YAMAHA

DX-7

BULLETIN NO. E-325

Change of System ROMs in Accordance with Latest MIDI Standard Version, and Others

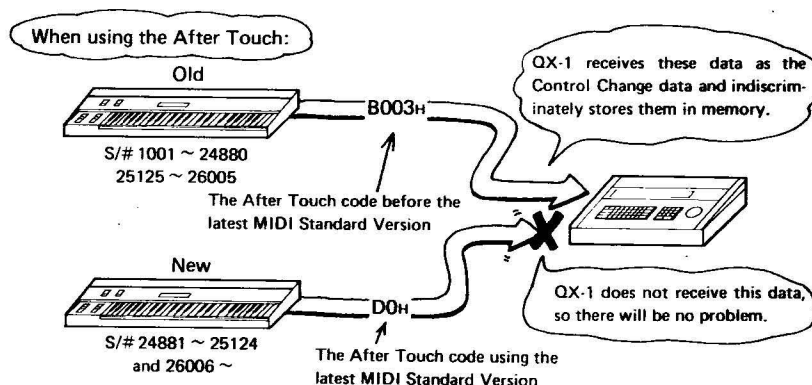
4. Troubles Caused with Differences in MIDI Standard Versions

In connection between the new DX-7 and old DX-7

- The After Touch codes are different !
Therefore, no effect can be obtained each other, even if either After Touch code is transmitted.

In connection between the old DX-7 and QX-1

- QX-1 does not recognize B003H transmitted from the old DX-7 as the After Touch code, but receives it as the Control Change code and stores it in memory.
- Since the old DX-7 employs B003H as the After Touch code and these (B003H) data are transmitted in a great amount when the After Touch is used, these data soon fully occupy the memory area in QX-1. Consequently, QX-1 cannot sufficiently store data for performance in memory, so that it fails to carry out its proper functions in this MIDI communication.

- **Countermeasure:**

If the following operating procedures are followed, the above problem can be avoided. Naturally, these will be explained in future Operating Manuals. When you have received the customer's complain, please service by fully explaining the following operation procedures.
